# **OEHI Responses to CEC Set 3 Data Requests Nos. A178 - 180**

Amended Application for Certification  
for  
HYDROGEN ENERGY CALIFORNIA  
(08-AFC-8A)  
Kern County, California

February 2013

Key Observation Point Photo Simulation  
Methodology and Summary

Figure 1.2-1A

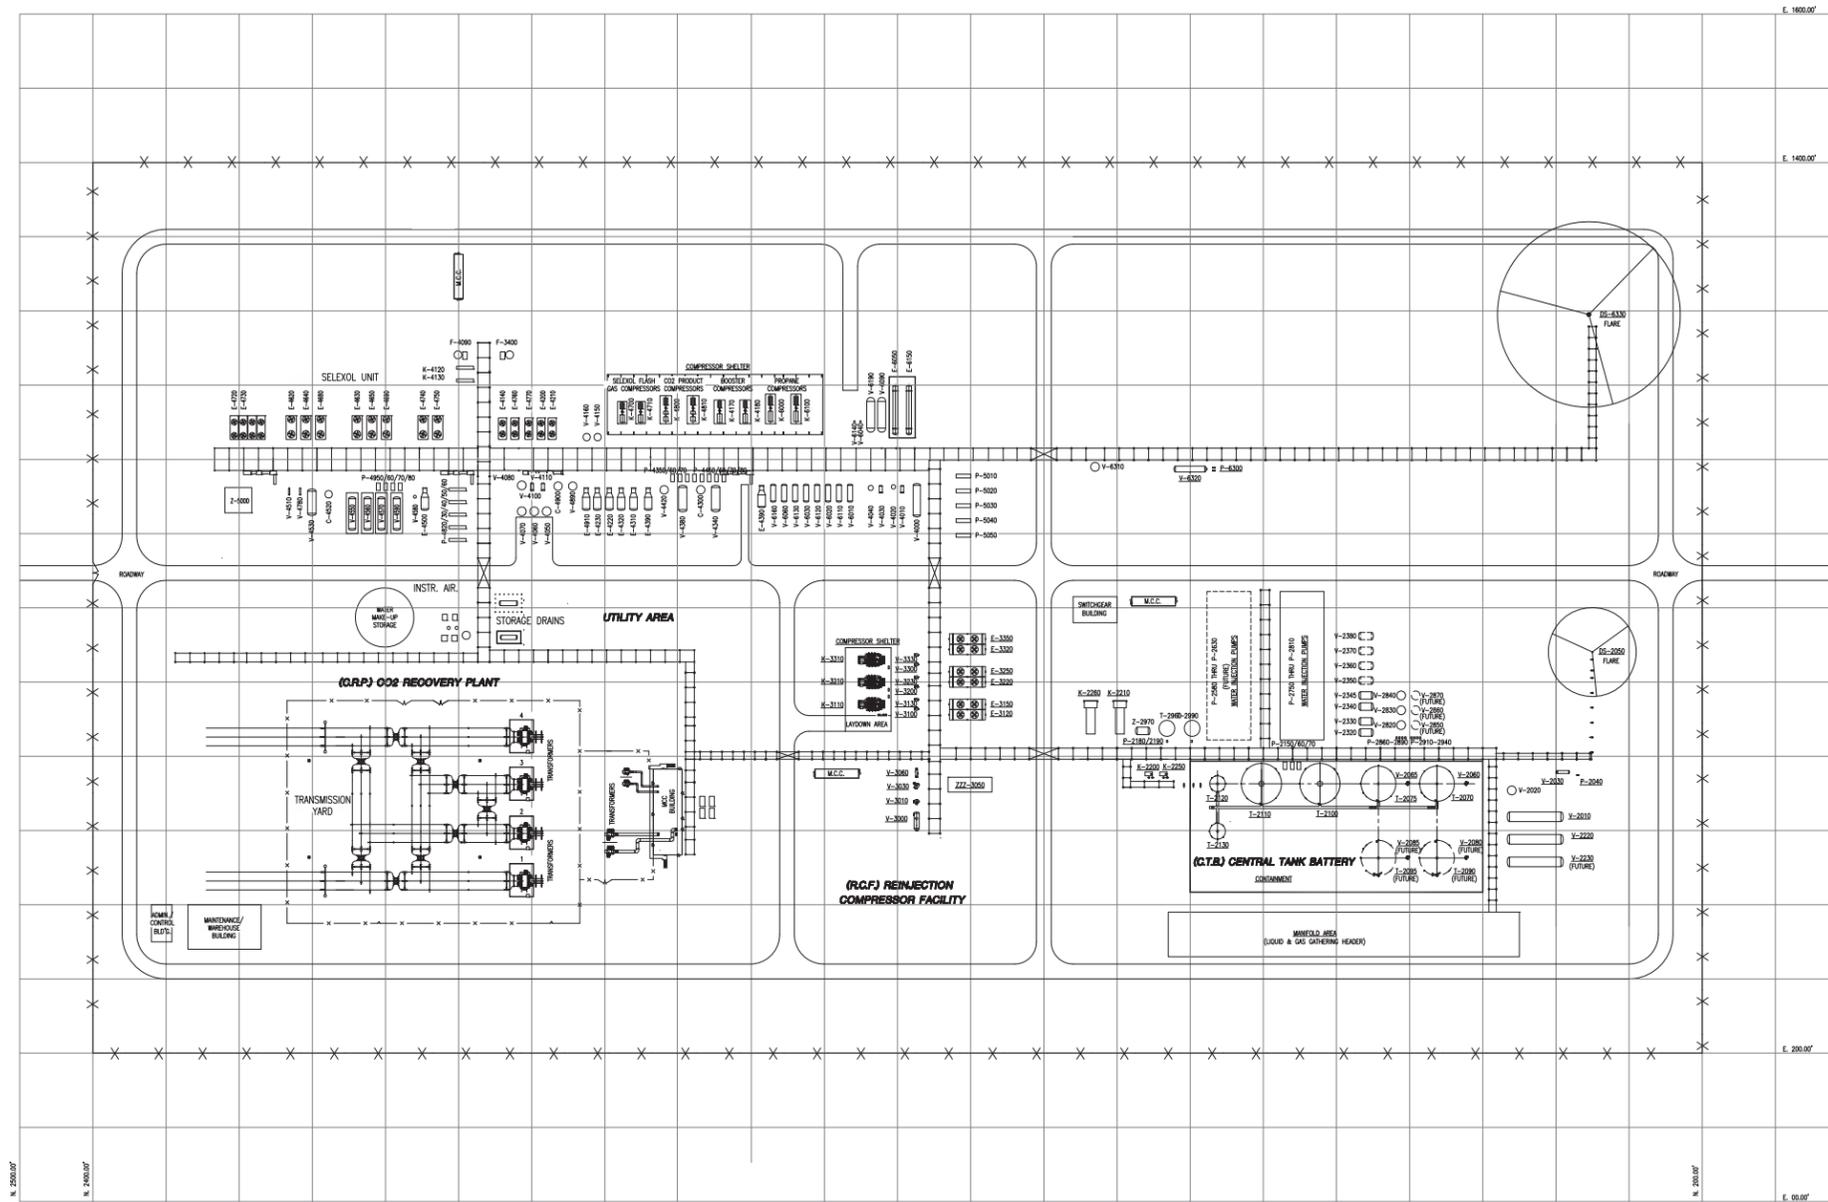
A180. Please provide information on the dimensions (i.e. height and width) of all the proposed above ground structures.

The design dimensions of equipment and structures used in the simulations are included.

plan drawings (see Figures 1.2-1A and 1.2-1B) in the absence of detailed elevation information. Colors and finishes were not provided. It was assumed that the features would be colored/finished per the mitigation requirements of the Supplemental Environmental Information document (Mitigation Measure 4.1-1).
